Access Compliance Report

Public Rights-of-Way

Intersection ID: 31690	Main Street: JAKOBSON_DR	Cross Street: TRIECE_LN	Location: SE
ADA ID: 73EDFD3D41DA	Ramp Type: PerpDiag	Initial Pass/Fail: Fail	Overall Compliance: No
		Severity Score: 17.5

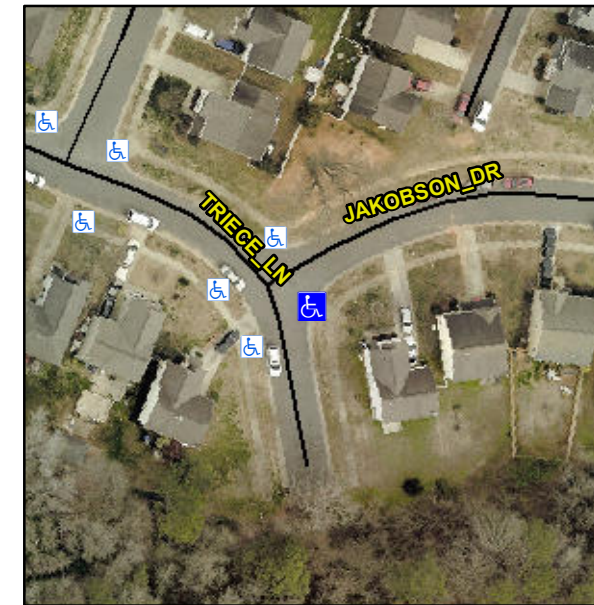
Not Found, R304.5.1

Compliance	Description	Data	Compliance	Description	Data
N/A	Ramp Length (in)	96.0	Yes	Ramp Slope (%)	7.3
No	Ramp Width (in)	34.0	Yes	Ramp XSlope (%)	1.0
N/A	Flare Type LT	N/A	N/A	Flare Type RT	N/A
N/A	Flare Slope LT (%)	N/A	N/A	Flare Slope RT (%)	N/A
N/A	Flare Traversable LT?	N/A	N/A	Flare Traversable RT?	N/A
N/A	Landing Length (in)	N/A	N/A	DWS Provided?	N/A
N/A	Landing Width (in)	N/A	N/A	DWS Contrast?	N/A
N/A	Landing Slope (%)	N/A	N/A	DWS Length (in)	N/A
N/A	Landing X Slope (%)	N/A	N/A	DWS Full Width?	N/A
N/A	Landing Curb? (Y/N)	N/A	N/A	DWS Offset (in)	N/A
N/A	Shared Landing?	N/A			
N/A	Gutter Ponding?	N/A	N/A	Gutter Slope (%)	N/A
N/A	Gutter Lip Ht (in)	N/A	N/A	Gutter X Slope (%)	N/A
N/A	Painted X Walk1?	No	N/A	Painted X Walk2?	No
	X Walk 1 Direction	To NW		X Walk 2 Direction	To SW
N/A	X Walk 1 Width (in)	N/A	N/A	X Walk 2 Width (in)	N/A
	X Walk 1 Slope (%)	1.9		X Walk 2 Slope (%)	3.2
	X Walk 1 X Slope (%)	2.0		X Walk 2 X Slope (%)	4.3

Remove & Replace Curb Ramp With Two New Directional Ramps or Equivalent.
